DRSSTC CONTROLLER
STEVEN WARD 2008
REVISION 1.1b

Modified 6/25/2009

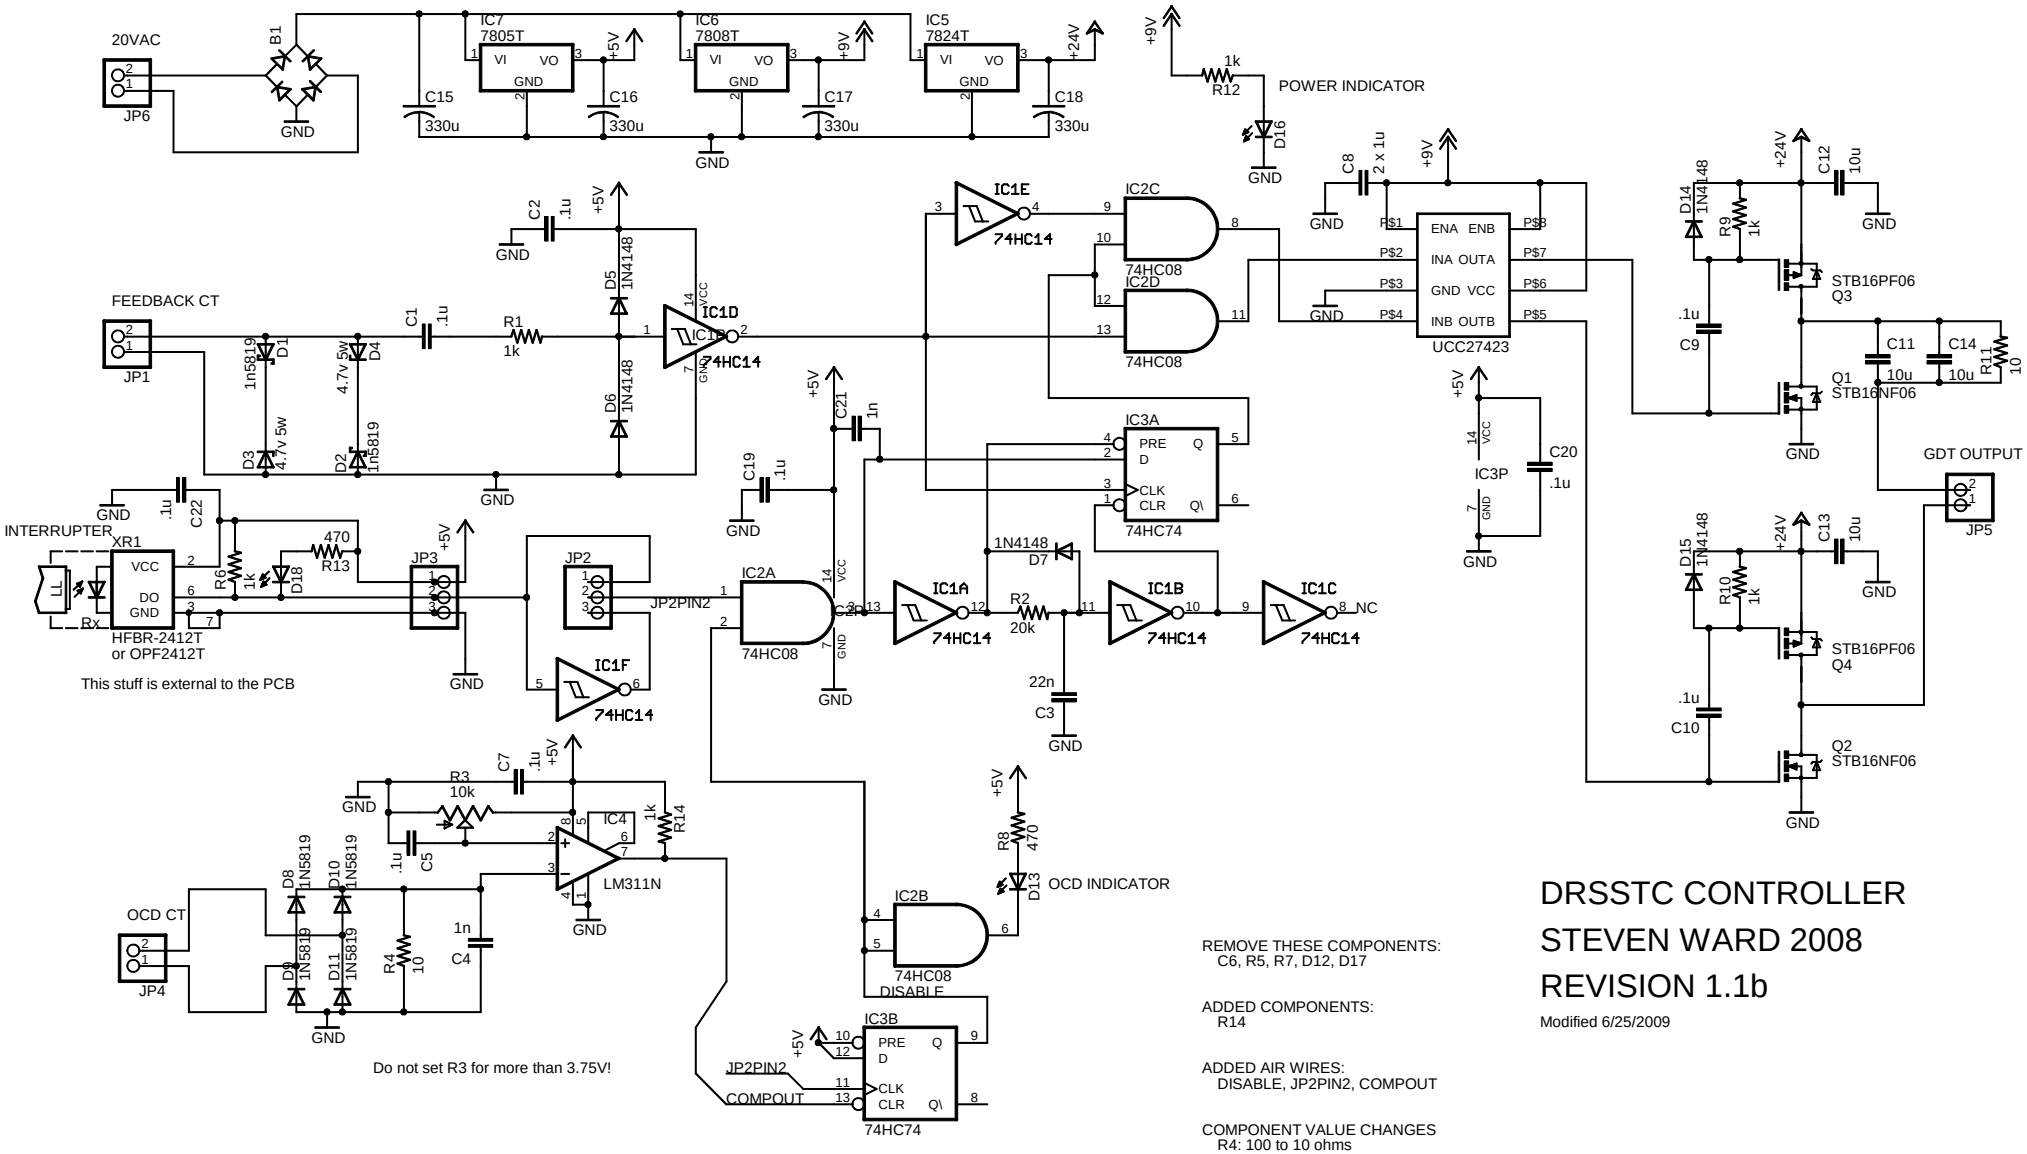
REMOVE THESE COMPONENTS:
C6, R5, R7, D12, D17

ADDED COMPONENTS:
R14

ADDED AIR WIRES:
DISABLE, JP2PIN2, COMPOUT

COMPONENT VALUE CHANGES
R4: 100 to 10 ohms
D8-11: 1n4148 to 1n5819
C4: 100nF to 1nF
